## NOTICE OF APPROVAL

**Planning Case #:** Design Study 24162

**Project Description:** This approval of Design Study (DS 24162 (Turner)) authorizes amendments to existing Design Study Approvals (DS 20-196) for alterations to an existing single-family residence located at Mission 5 NW of Santa Lucia in the Single Family Residential (R-1) District. The modifications approved under this Design Study include: 1. The addition of a new stone veneer to the East and North Elevations of the property; 2. The relocation of a window from the North side of the property to the South side; 3. The addition of a window to the upper level of the South side of the property; 4. The replacement of the proposed horizontal picket and plaster column fencing with vertical wood picket fencing; 5. The replacement of the proposed standing seam metal roof with composite shingles. Alterations not expressly listed in this authorization are not permitted. The project shall be consistent with the plans dated approved by Community Planning & Building Department on August 20, 2024, unless modified by the conditions of approval contained herein.

**Project:** DS 24162 (Turner)

SITE PLAN  
 (PROPOSED)

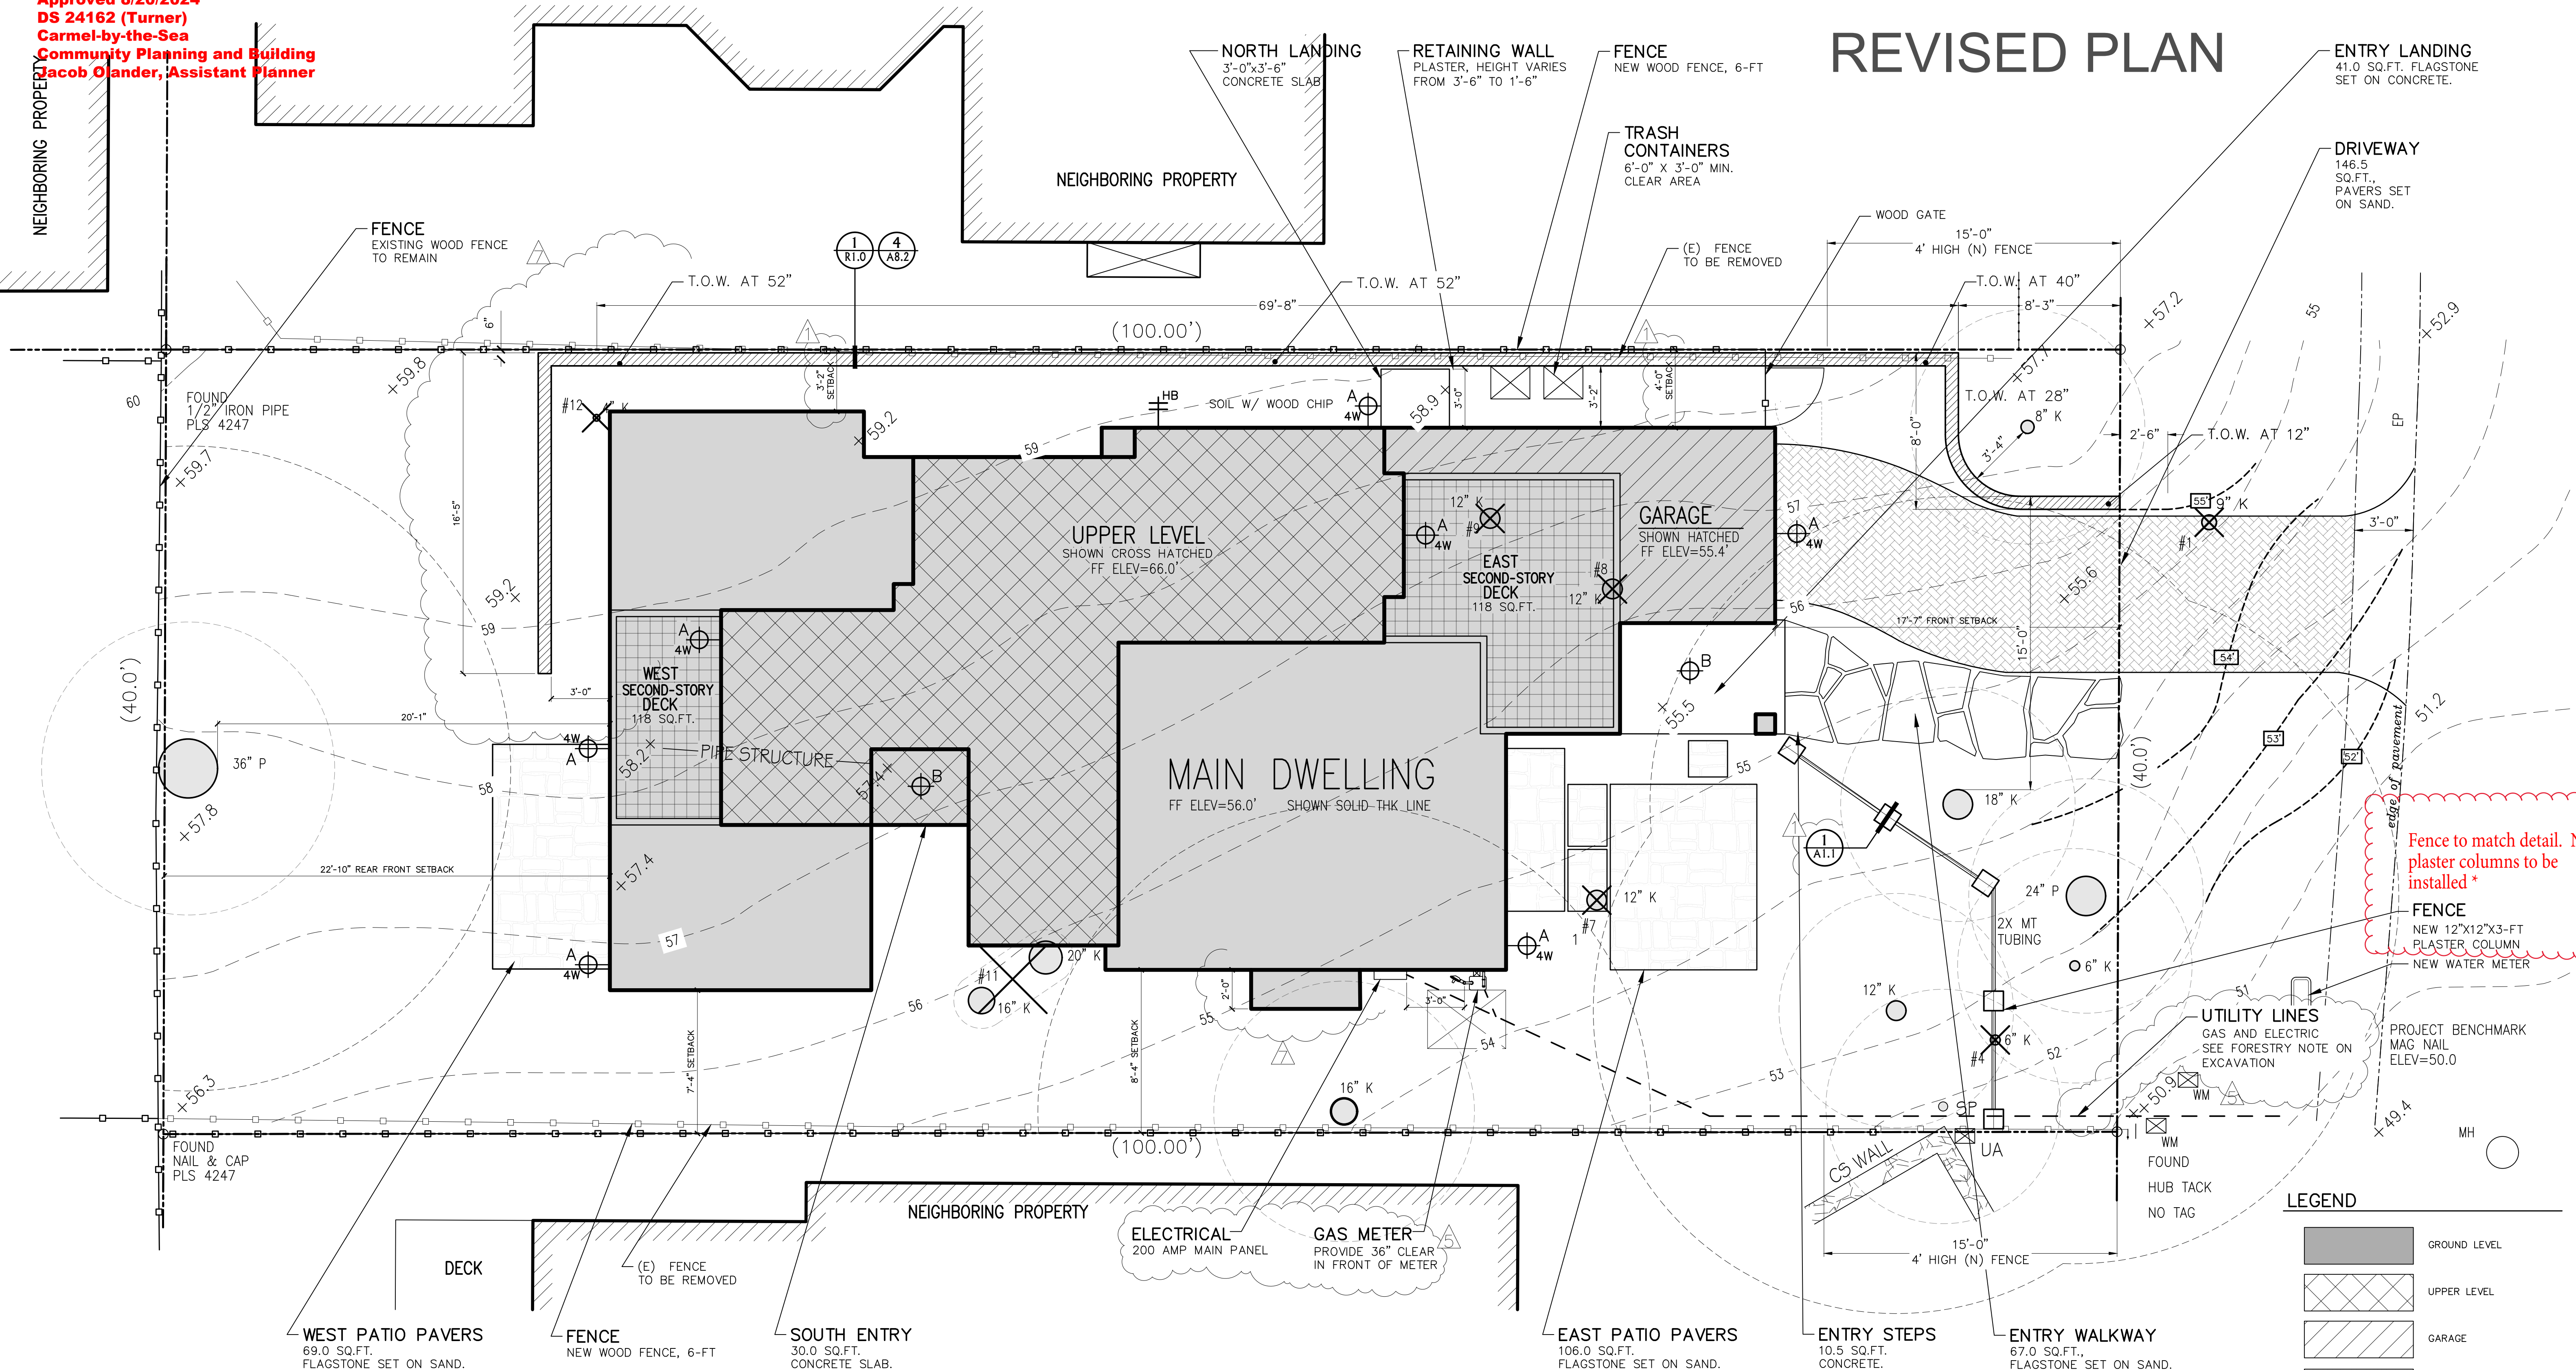
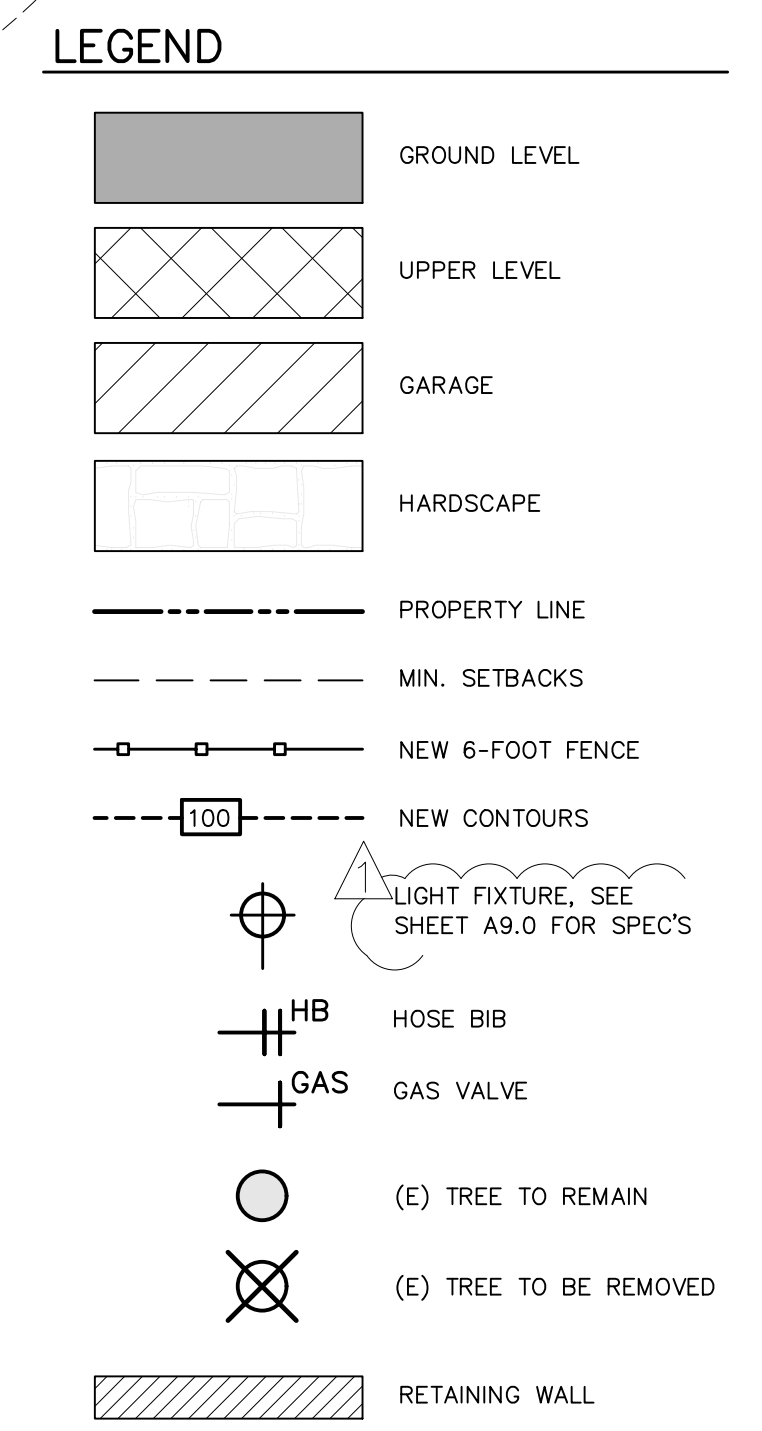
Fence to match detail. No plaster columns to be installed \*

EAST ELEVATION

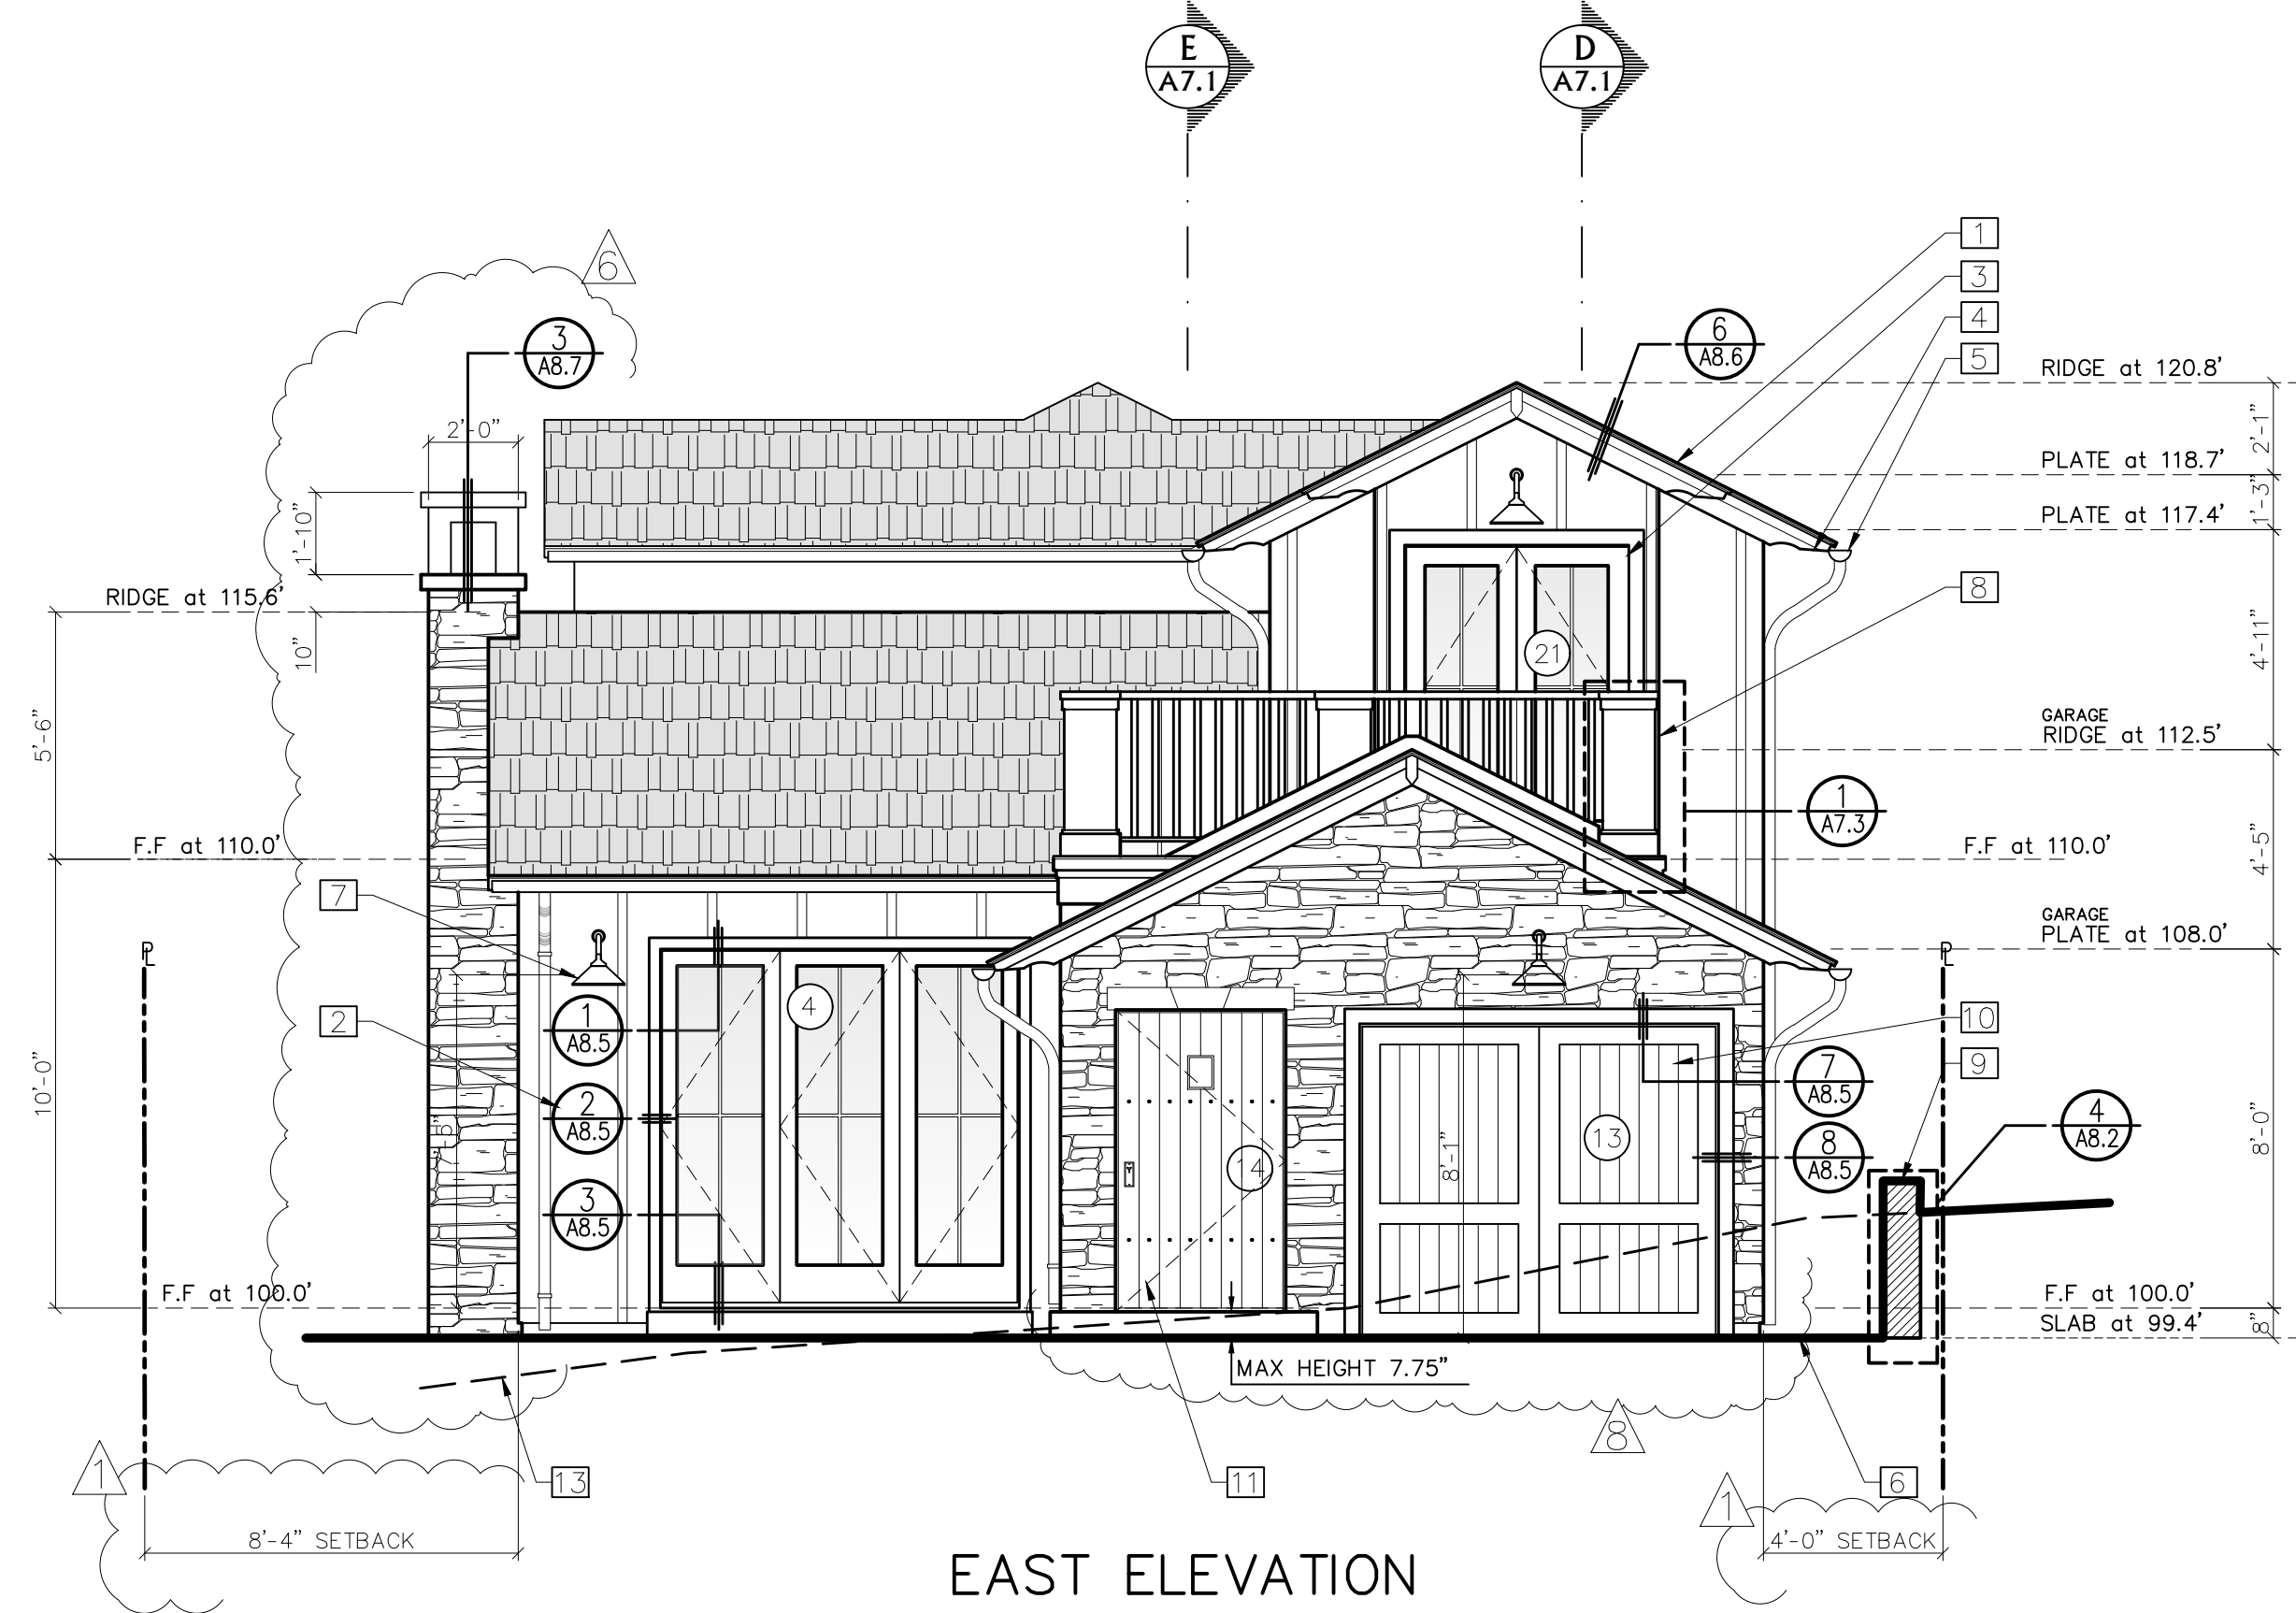
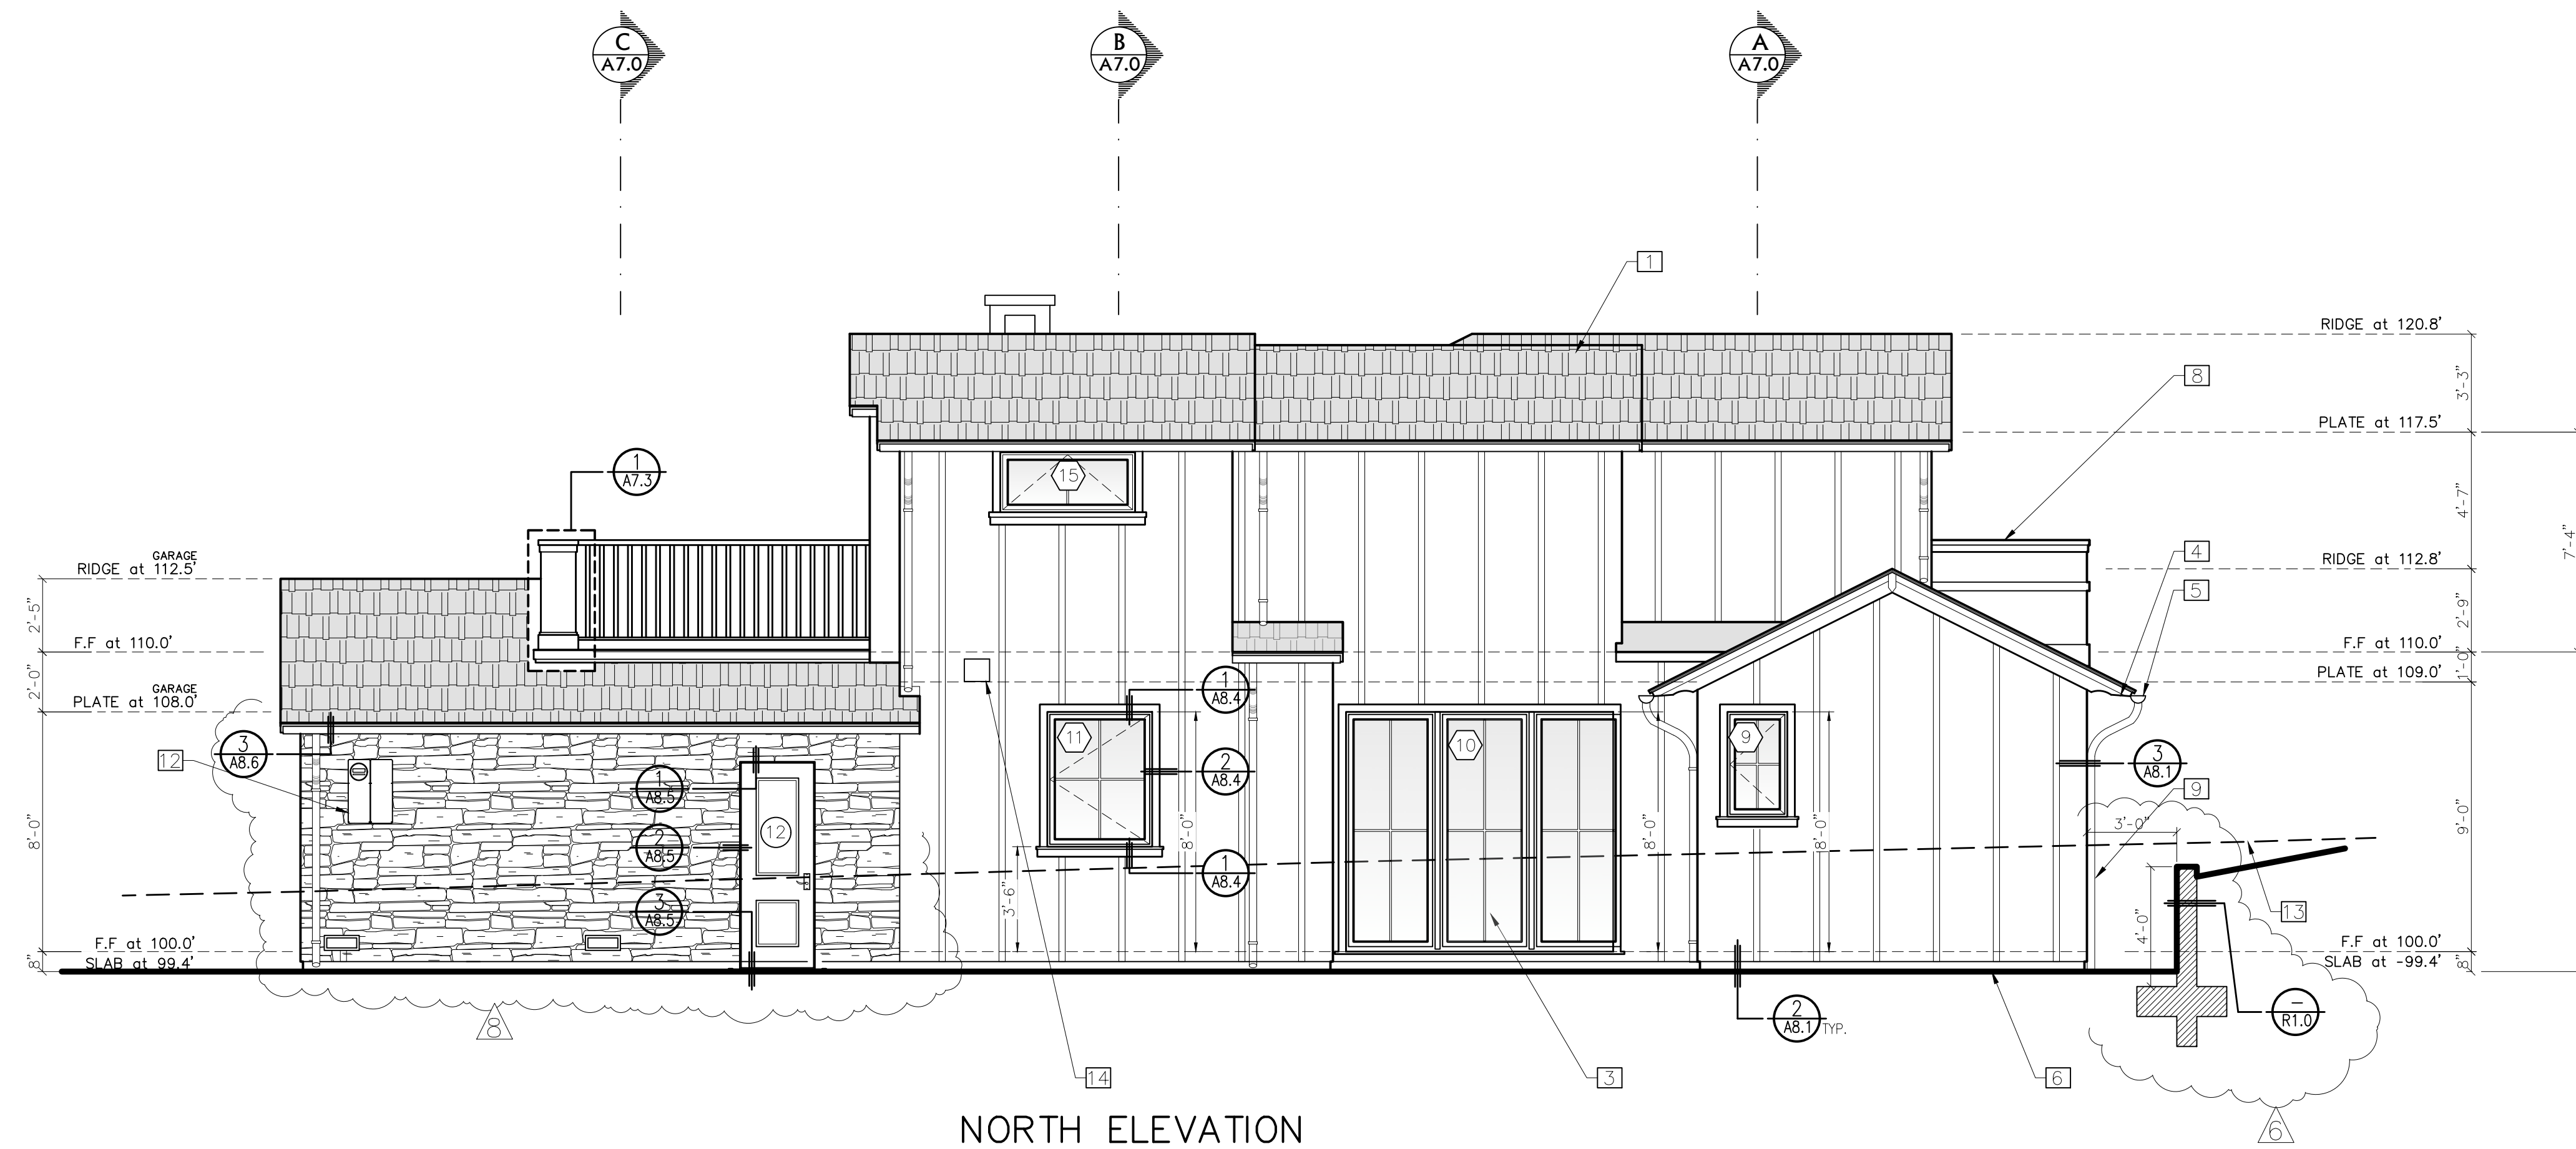
REV 05/25/24  
 1. ADDED MUNTINS TO THE WINDOWS AND DOORS  
 2. ADDED STONE VENEER TO THE GARAGE
